Reference: Engineering Services  
1614 McLamb Rd.  
Lillington, NC 27546  
TE&D Project No.: 2401-020923

- 1) Inspection of the framing for the accessory storage building.

Item 1.A. Right wall reinforcement:

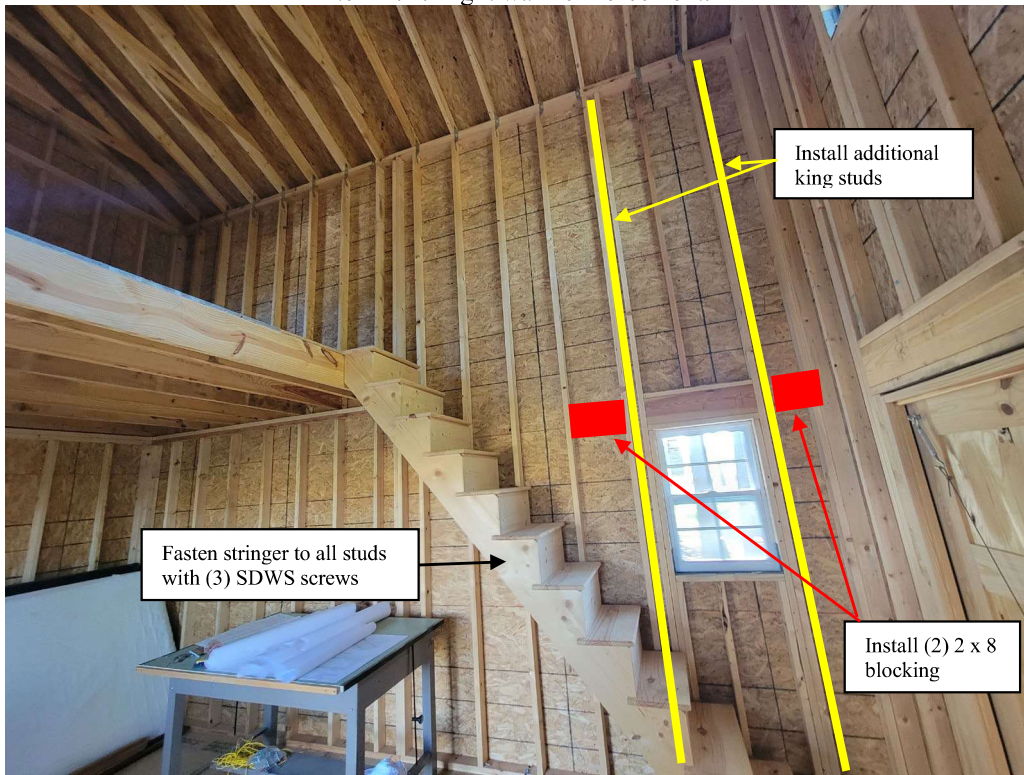
- The right wall is to be reinforced by installing an additional king stud at each end of the window header and new (2) 2 x 8 blocking is to be installed from the window header to the front corner of the structure and back a minimum of 16" from the window header. Additionally, all studs are to be fastened to the stair stringer with a minimum of (3) SDWS screws.

Item 1.A. Left Wall:

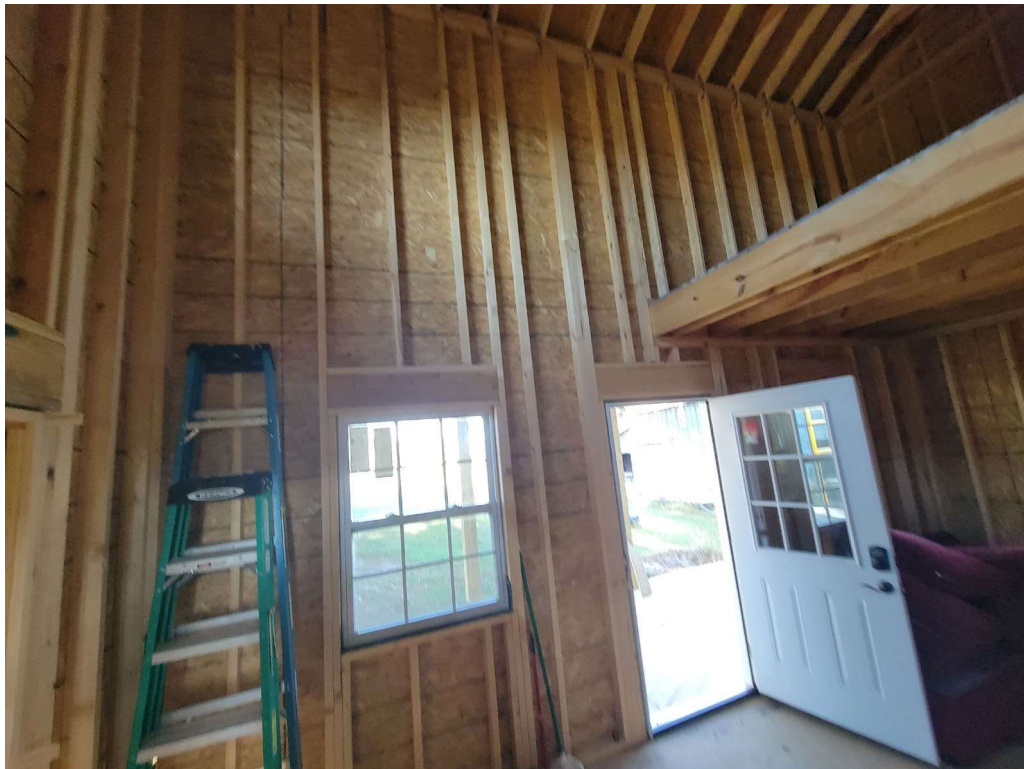
- The left wall is adequate as constructed as the wall is laterally braced by the shed roof over the front porch.
  - B) No header was installed over the 4'-0" wide front window. A new, minimum (2) 2 x 6 header is to be installed over the window with (2) 2 x 4 jacks and (1) 2 x 4 king stud at each end.
